### **NFPA Technical Committee on Residential Sprinkler Systems (AUT-RSS) NFPA 13D/R First Draft Meeting (A2024)**

July 6-7, 2022  
8:00 a.m. – 5:00 p.m. (MT)

<u>File Name</u>	<u>Description</u>	<u>Approved</u>
JackAndJill.png	Jack and Jill Bathroom

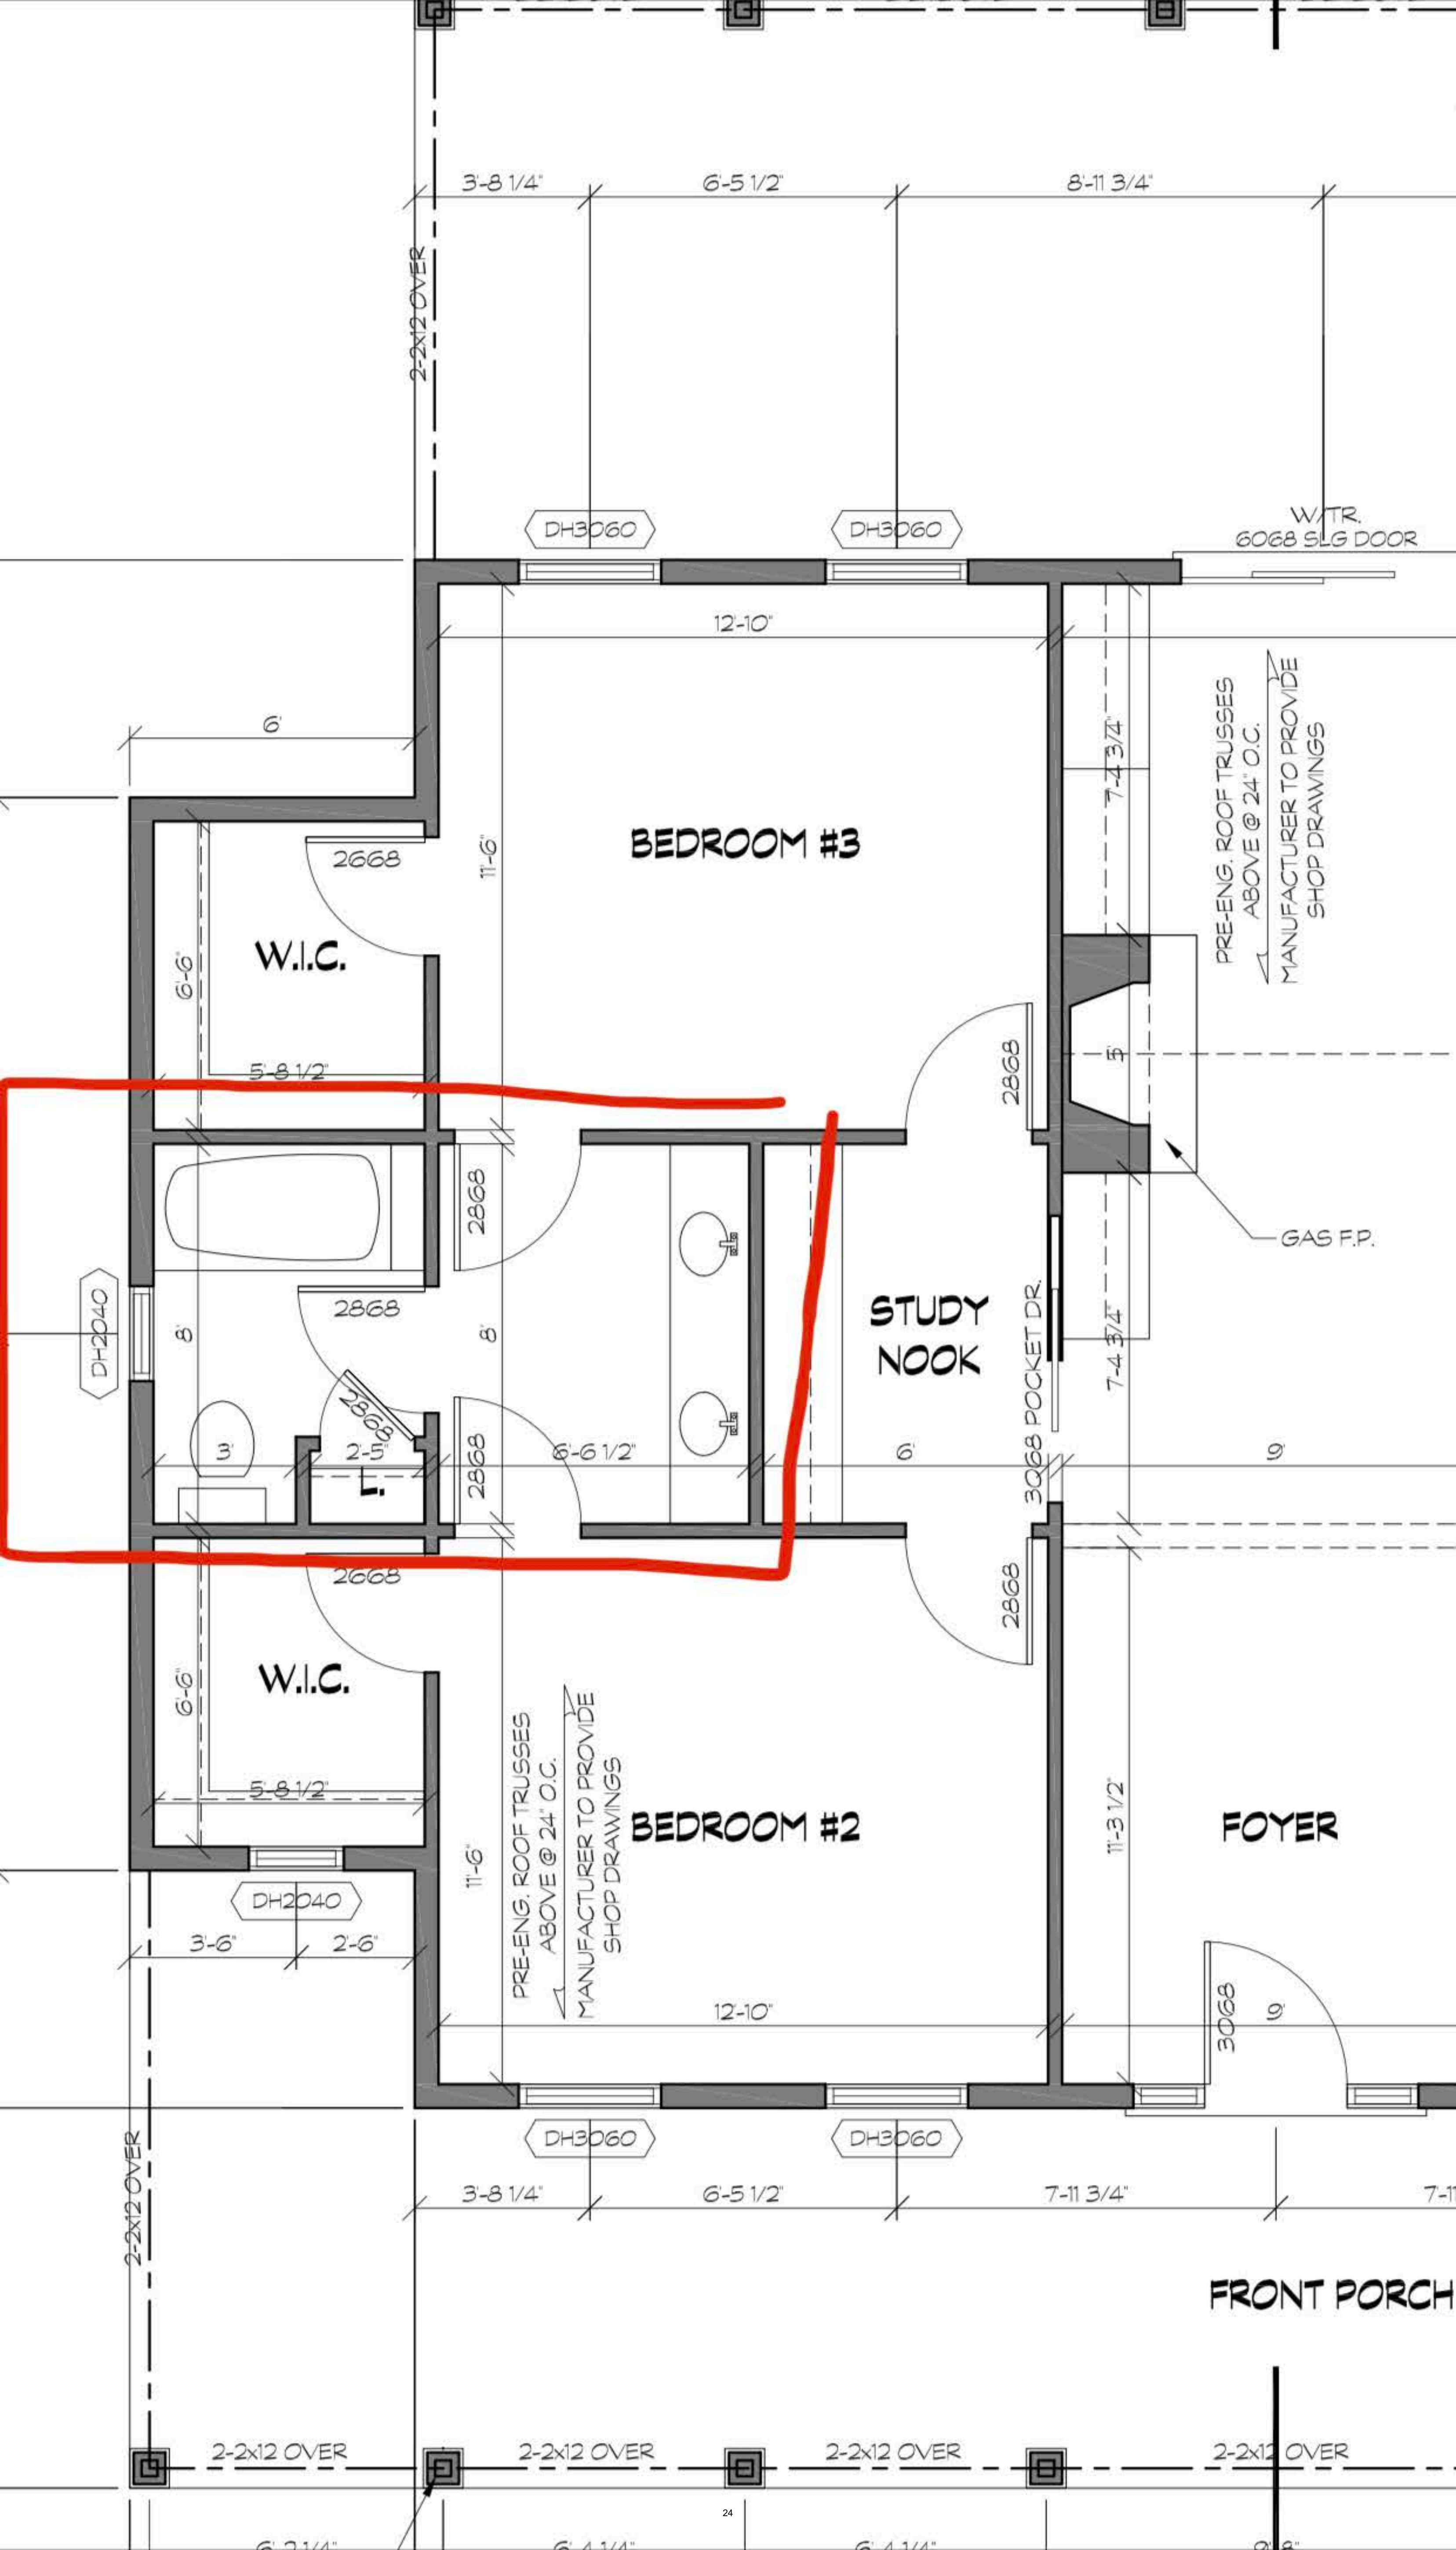
In a Jack and Jill bathroom where the sink is separate from the tub/shower, toilet, and linen closet area there needs to be a consideration and instruction for this in the code. In our new house both of these areas (1. tub/shower, toilet, linen and 2. separate sink area) are counted as separate 'bathroom' spaces and sq ft is considered separately; individually these spaces are less than 55 sq ft each (and therefore under 13D do not require a sprinkler). However, together they are 92 sq ft and now I have 92 sq ft of a significant area of egress in my home that is uncovered/unprotected by sprinklers. In my opinion, this is a loophole or gray area. If a 'Jack and Jill' are going to fall under 'bathroom' code then the entire space should be looked at collectively and when over 55 sq ft in total, it should require a sprinkler regardless of separating walls or doors. So the code could be enhanced to say something like for Jack and Jill bathrooms that have delineation of space by walls/doors, the entire square footage of the area should be considered and if over 55 sq ft the space requires sprinkler coverage.

In our new house both areas of a Jack and Jill bathroom are counted (sq ft) as separate bathroom areas (1. tub/shower, toilet, linen and 2. separate sink area); individually these spaces are less than 55 sq ft each (and therefore under 13D do not require a sprinkler). However, together they are 92 sq ft and now I have 92 sq ft of significant area of egress in my home that is uncovered/unprotected by sprinklers. In my opinion, this is a loophole or gray area that requires clarification in the code. See attachment and note the area labeled 'Study Nook' is covered by one sprinkler.

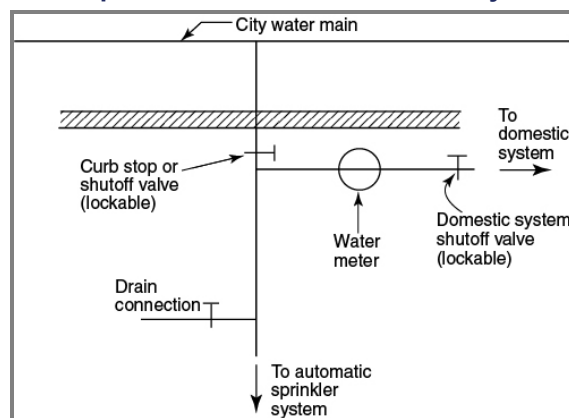
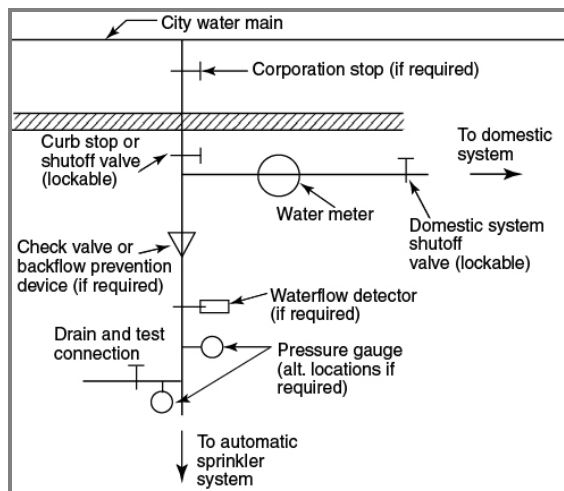
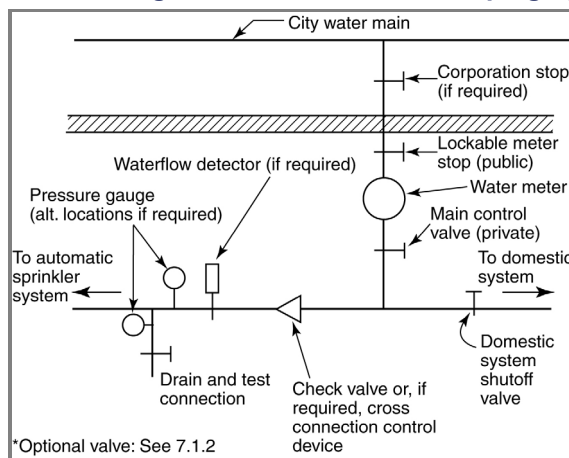
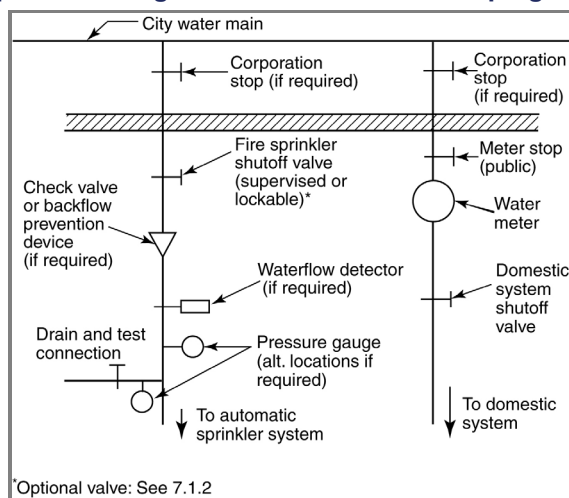
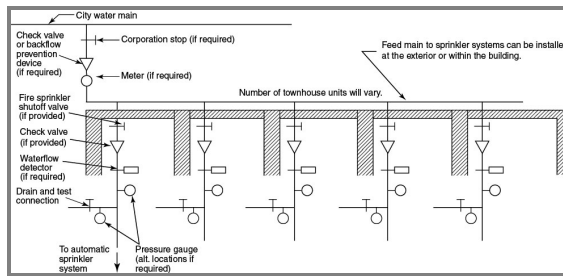
Figure A.6.2(a) ~~or~~ Figure A.6.2(c) ~~or~~ Figure A.6.2(d) ~~are~~ are acceptable methods for getting the water supply into the unit for a stand-alone sprinkler system (one that does not also provide direct connections to the cold water fixtures) because the common supply pipe for the domestic system and the sprinkler system between the water supply and the dwelling unit has a single control valve that shuts the sprinkler system, which helps to ensure that people who have running water to their domestic fixtures also have fire protection. This serves as a form of supervision for the control valve and can be used to make sure that the valve stays open in place of other, more expensive options such as tamper switches with a monitoring service.

Some water utilities choose to install separate taps and supply pipes from the water supply to the dwelling unit for fire sprinkler systems as shown in Figure A.6.2(d), due to the preference to not shut off water to piping that includes fire supply as well as domestic water supply. While these types of arrangements are acceptable, they might not be cost efficient and should be evaluated due to the extra cost burden this places on the building owner.

Figure A.6.2(d) should be removed from this sentence. This paragraph describes "...the common supply pipe for the domestic system and the sprinkler system between the water supply and the dwelling unit has a single control valve that shuts the sprinkler system..." and Figure A.6.2(d) illustrates two separate taps, which is described in the next paragraph of this Annex text A.6.2.

<u>File Name</u>	<u>Description</u>	<u>Approved</u>
Figure_A.9.1.2.2.jpg

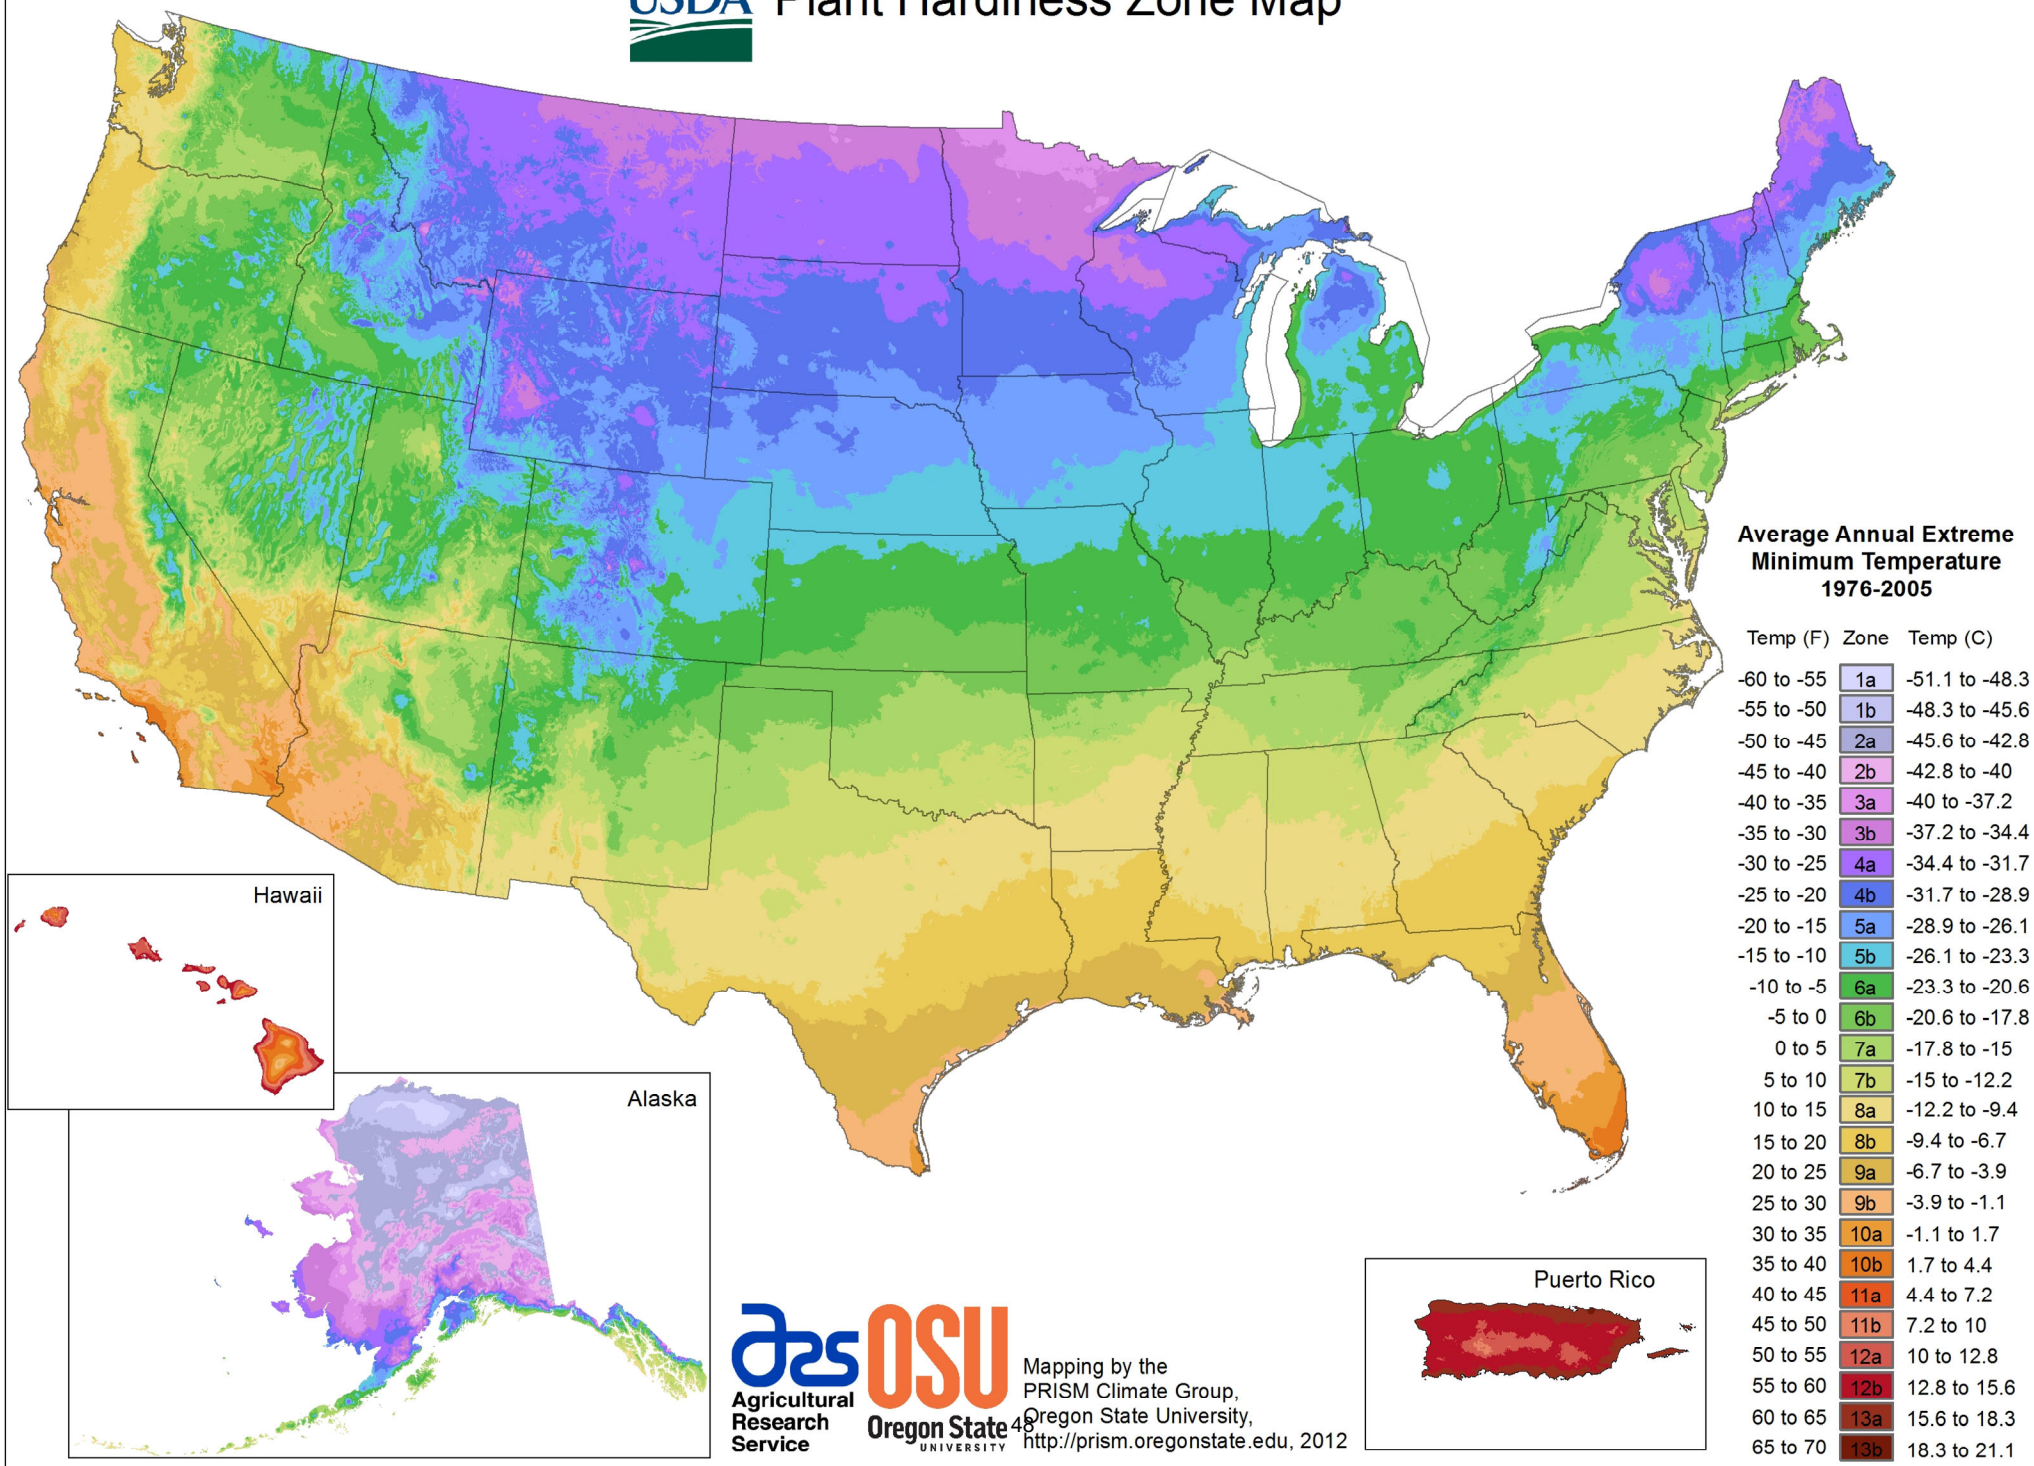
- (1) National Oceanic and Atmospheric Administration — National Climatic Data Center
- (2) National Weather Service
- (3) Plant Hardiness Zone Maps (See <https://planthardiness.ars.usda.gov>). See [Figure A.9.1.2.2](#).
- (4) American Society of Heating, Refrigerating and Air-Conditioning Engineers (ASHRAE)
- (5) Other approved sources

Add a map to aid the the user of the document.

**Figure A.10.4.4(6)  $\frac{5}{8}$  in. Water Meter Data from FPRF Tests.**

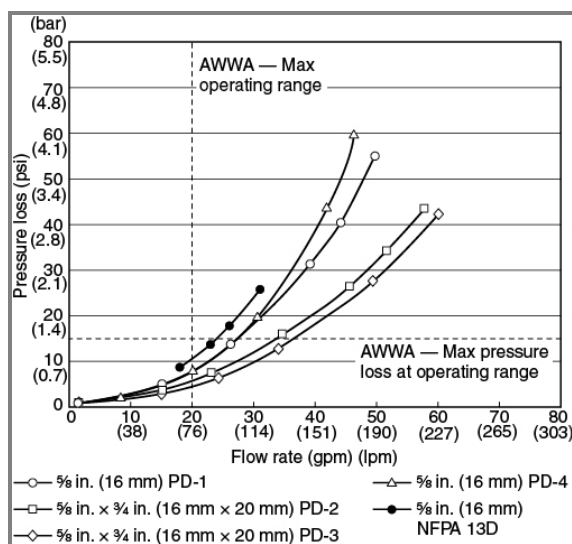
Section B.3.3 in Annex B of this document, *Incentives for Residential Fire Sprinkler Use — Advantages for Builders, Developers, and Communities*, includes additional information regarding residential water meters, including best practices and design options for utilizing new solid-state water meters, lower-flowing sprinklers, and other suggestions to assist with the use of residential water meters

This added annex A text is intended to point the reader to additional water meter information contained in the new Annex B, Incentives for Residential Fire Sprinkler Use — Advantages for Builders, Developers, and Communities. The use of lower-flowing sprinklers and new solid state meters can potentially result in a better experience with sprinklers for the home-builder / homebuyer, and increased collaboration with water purveyors.

<u>File Name</u>	<u>Description</u>	<u>Approved</u>
NFPA_13R_flexible_dry_sprinkler_figures.docx	New Figures A.6.2.4.1(c) and (d)

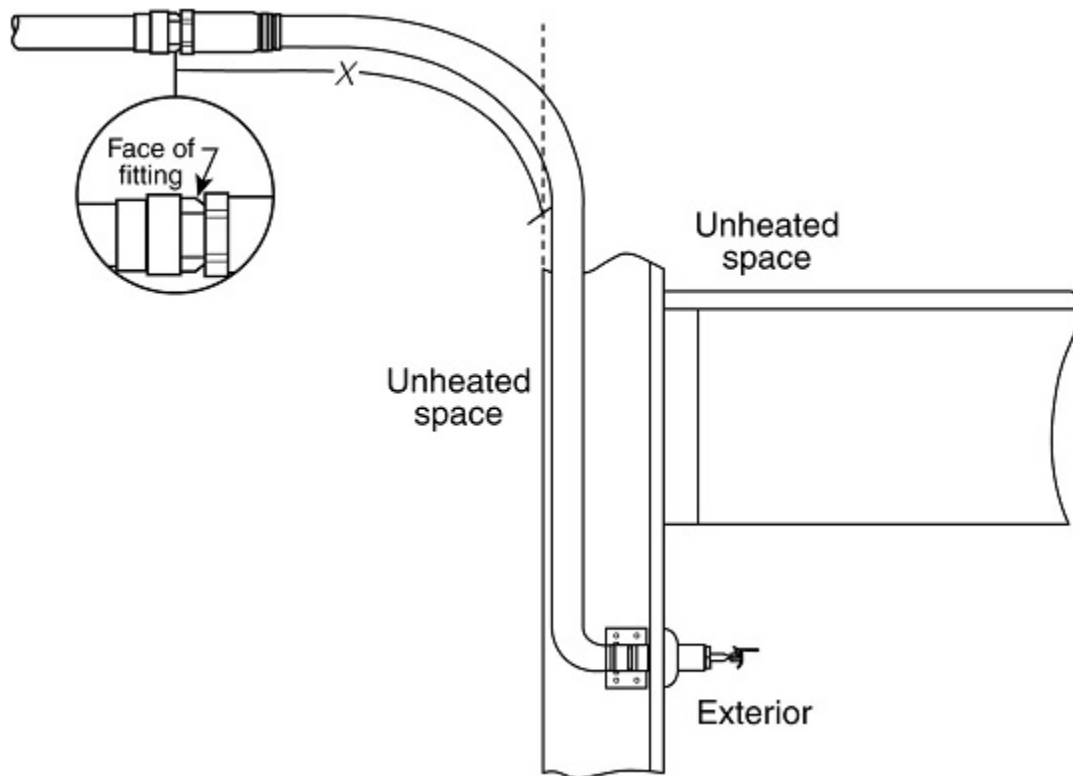
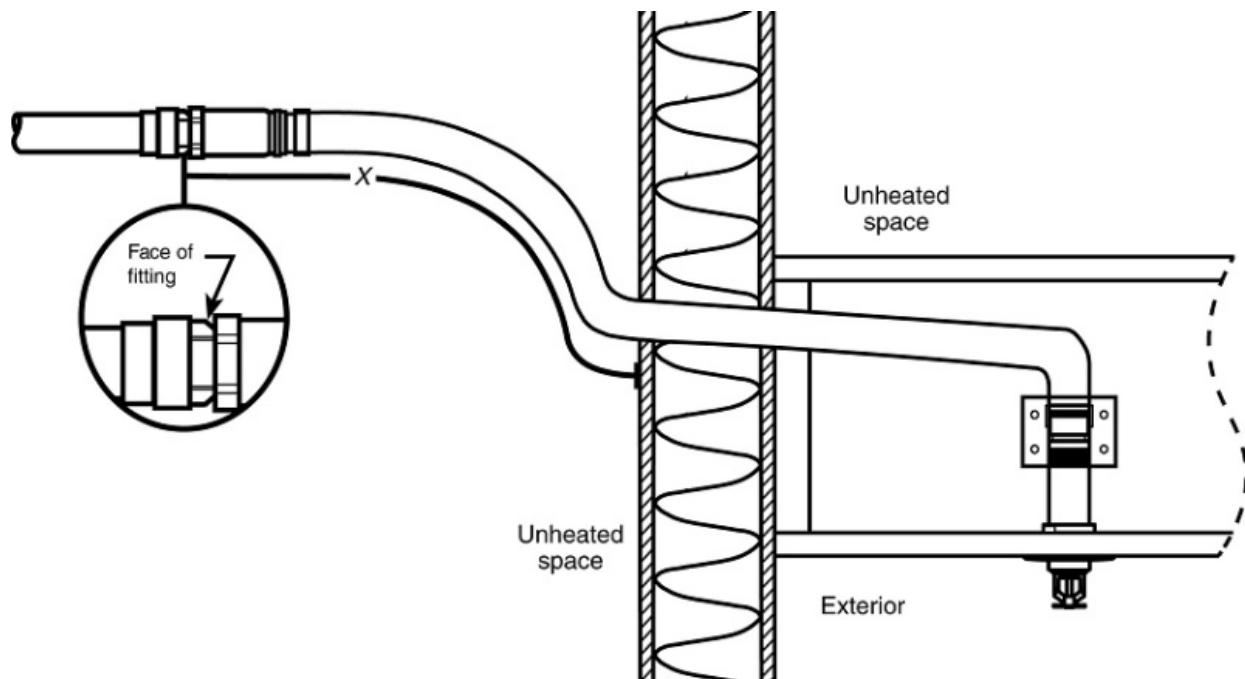
Flexible Dry Sprinklers are now available as an option for areas subject to freezing. Adding two new Figures A.6.2.4.1(c) and (d) will provide guidance for the user on where to measure the barrel length. These Figures are also in NFPA 13.
